PUBLIC HEARING/WORKING SESSION MEMORANDUM

PETITIONS #26-20 & #27-20

355 and 399 Grove Street

To: Neil Cronin, Planning and Development Department, City of Newton
From: Green International Affiliates, Inc. (Green)
Date: June 26, 2020
Project Name: Riverside Station
Project Number: Green No. 18078
Subject: Transportation Peer Review Response Letter

Figure 2B
 Vehicular Volume Totals and Deltas
 Weekday Evening Peak Hour Traffic Volumes

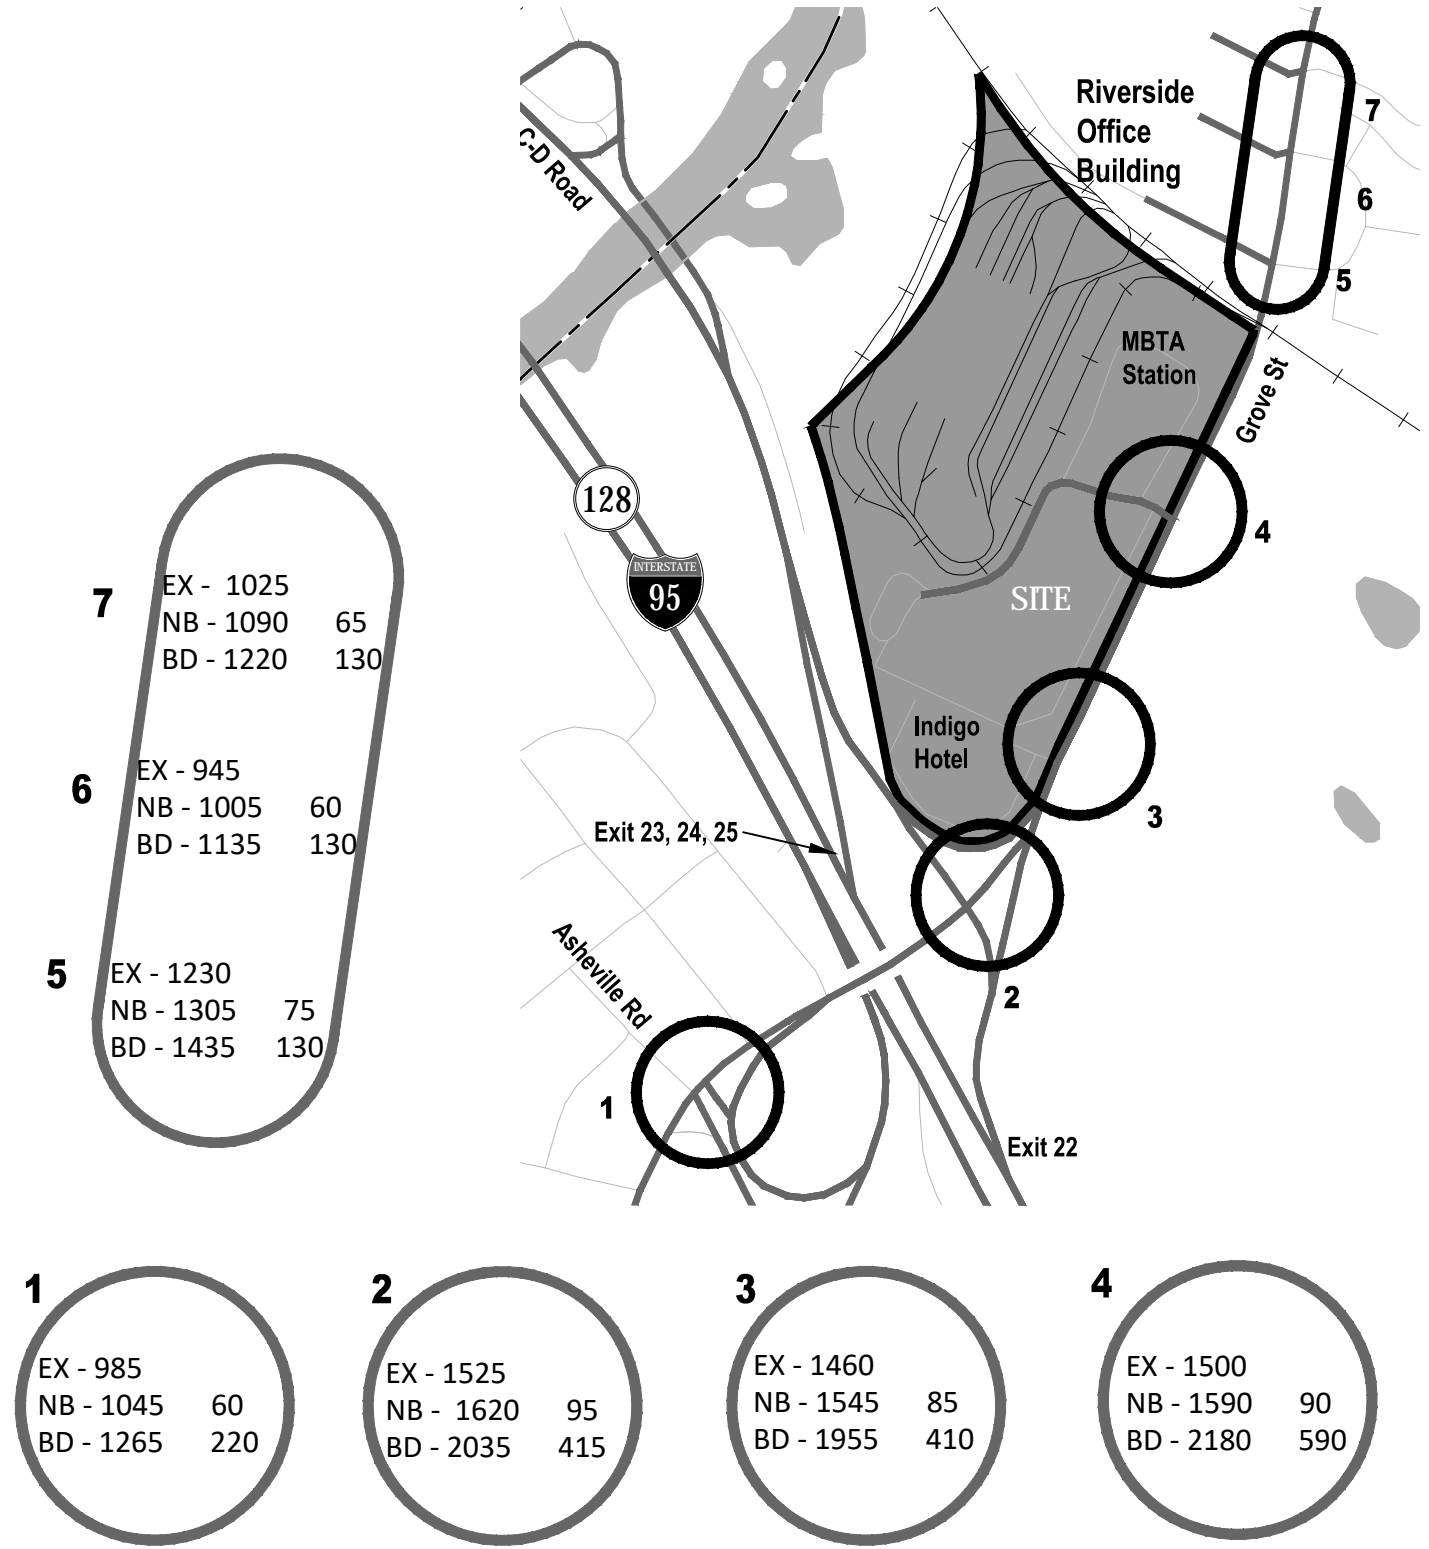
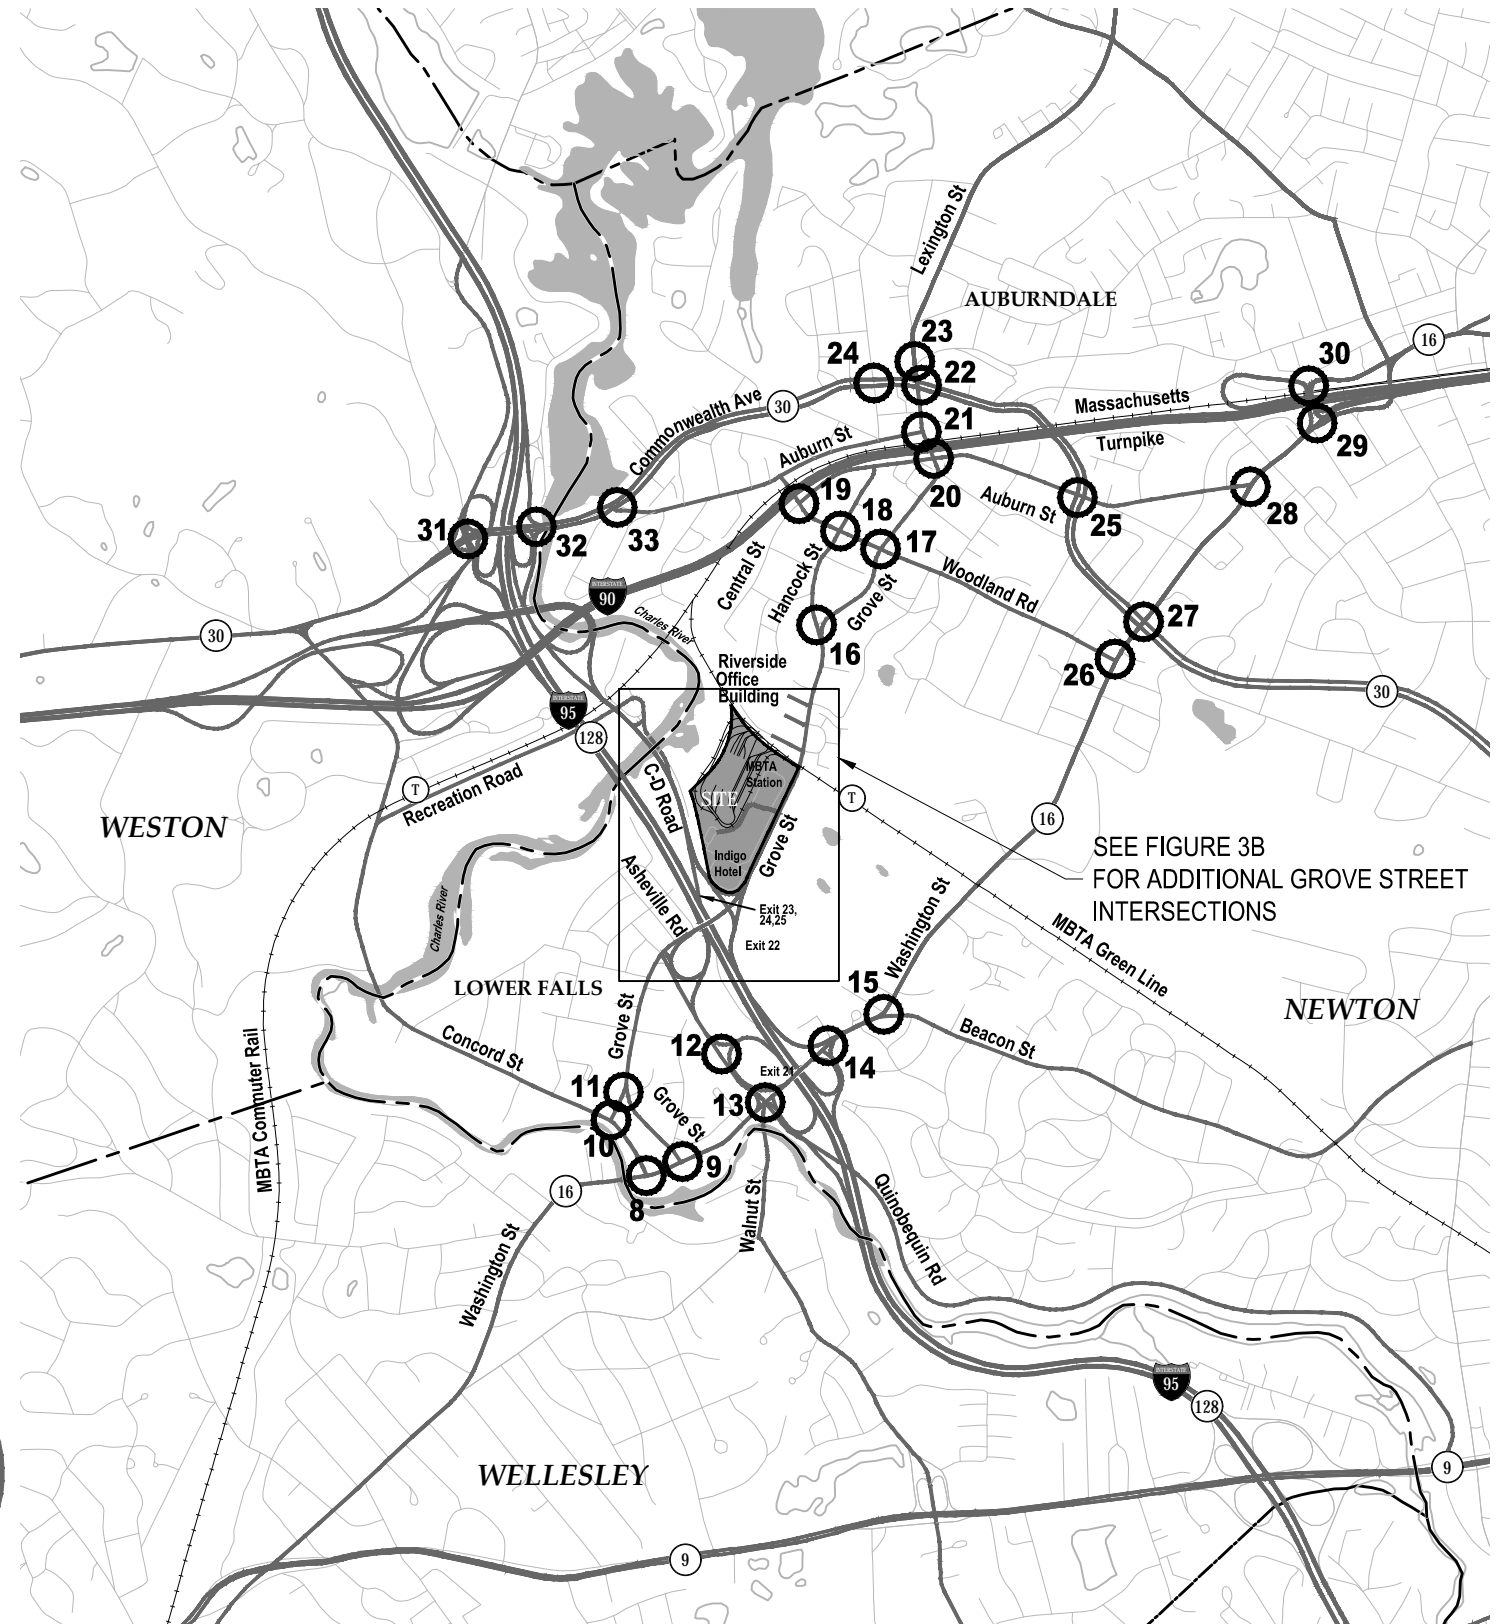
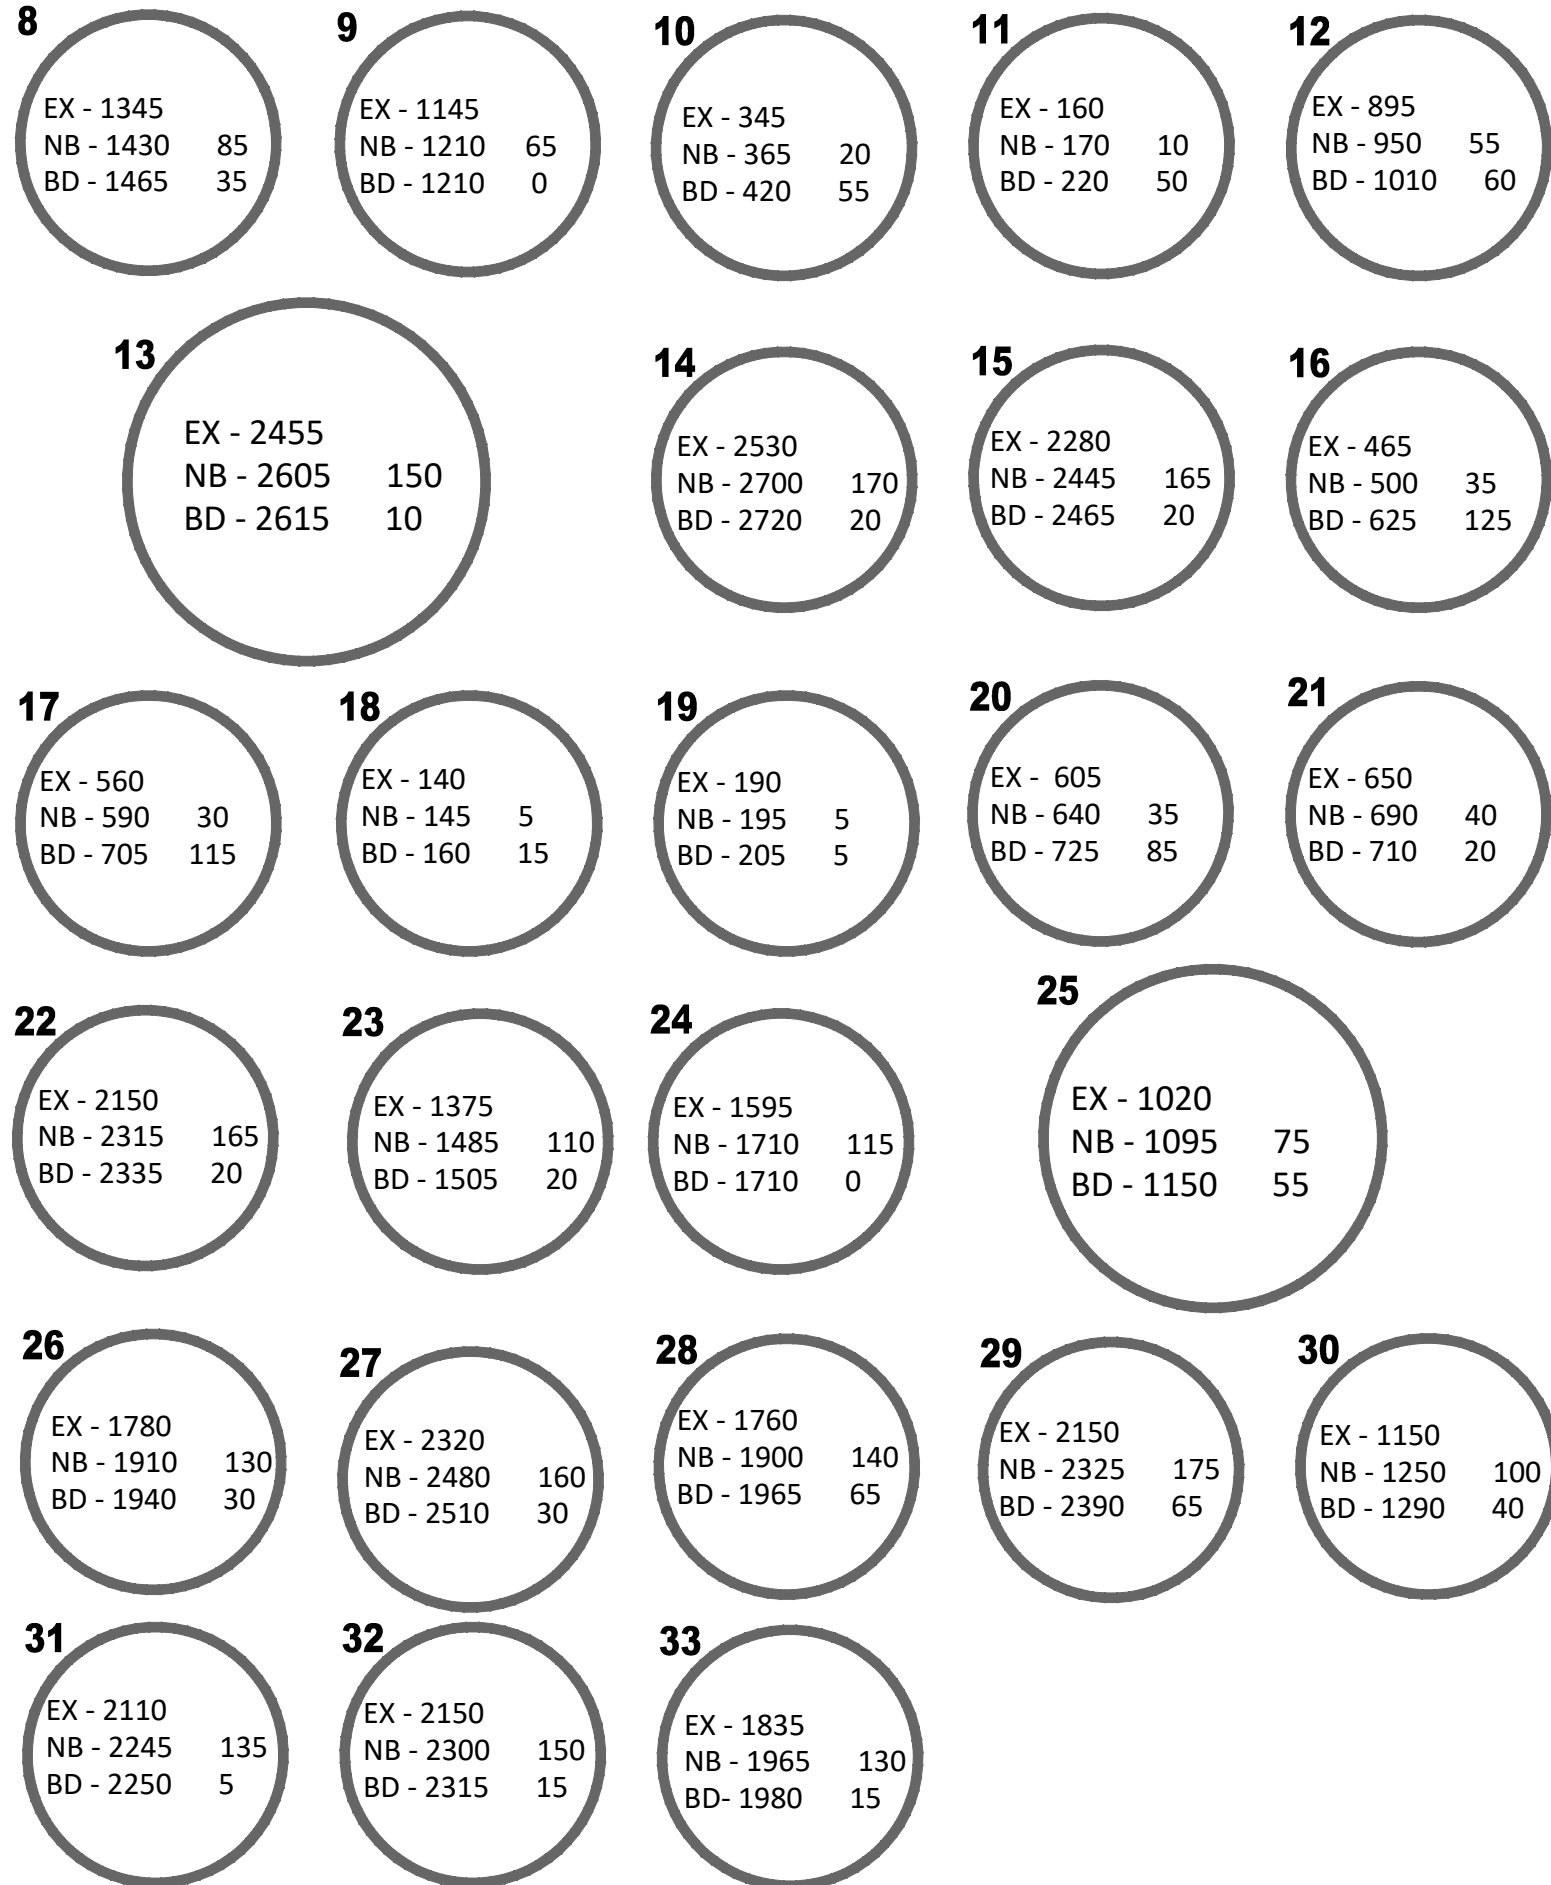
4. The memorandum provided a figure showing the increase in traffic at study area intersections during the peak hours. These trips represent the combination of all uses, residential, retail, office and hotel. While the individual uses have different trip distribution patterns, the figures provided show the combined effect on the roadway network. During the three peak hours, 210 – 220 new vehicle trips will be utilizing the new roundabout on Grove Street, 130-135 trips will be entering and exiting the site on Grove Street to the north, and a total of 370 – 415 trips will be entering from the Grove Street at Grove Street Extension intersection (including the trips utilizing the new roundabout). The developer should explain or correct the discrepancy shown on Figure 3B, where 10 vehicle trips disappear between Intersection 6 and Intersection 5, during the Saturday Peak Hour.
